19 January 2021

**Re: Objection to Development Application No. DA2020/1567**  
**Property: 9 Bate Avenue, Allambie Heights NSW 2100**

Geotechnical assessment of conditions related to stormwater/groundwater flow into  
No. 11 Bate Avenue, Allambie Heights.

Photo: 1 – Brick boundary retaining wall at rear of house

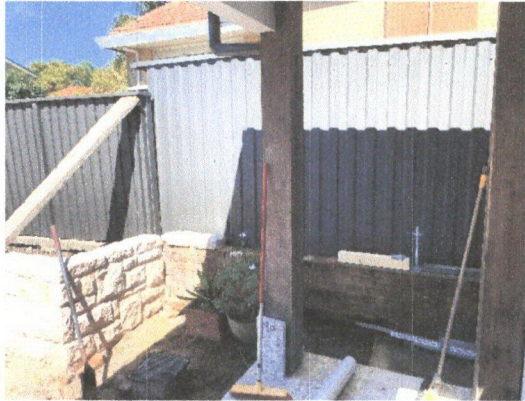
It is understood that as of at least early March 2020 that significant volumes of stormwater inflow to your property have occurred. This stormwater is flowing into your property below the low brick retaining wall on the boundary, adjacent to the rear south-west corner of your house, and has created a scour/erosion zone due to its flow with significant volumes of soils deposited in your property and your drainage system, see Photographs 1, 2 and 3.

Photo: 2 – Eroded channel below wall

Photo: 3 – showing eroded channel below wall and sandy soil deposited into site after 4<sup>th</sup> January 2021

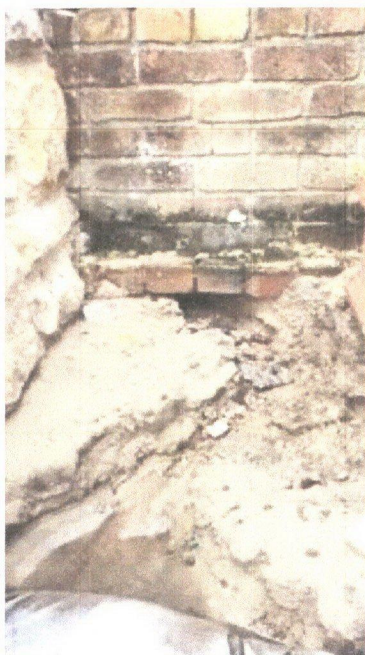
Inspection through the eroded zone into the sub-ground area of the neighbouring property revealed a significant zone of erosion below what appears to be the neighbouring carport slab along with the exposure of a PVC pipe, which is understood to be related to a stormwater easement formed along the eastern side of No. 9, see Photographs 3 and 4.

Photo: 4 - View of void eroded below neighbouring carport showing undermined PVC pipe near surface

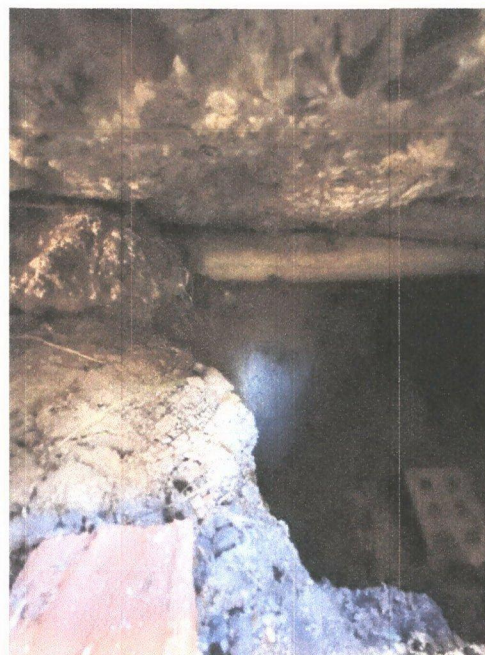
The photos from the void created below the neighbouring property show a PVC pipe which is anticipated to be the drainage pipe which was installed within the easement. The pipe is now significantly eroded and undermined and will be expected to have complete failure in the near future with likely further increases of stormwater flow and subsequent detrimental impacts to your property. As such, the issues related to the inflow need to be resolved in the immediate future.
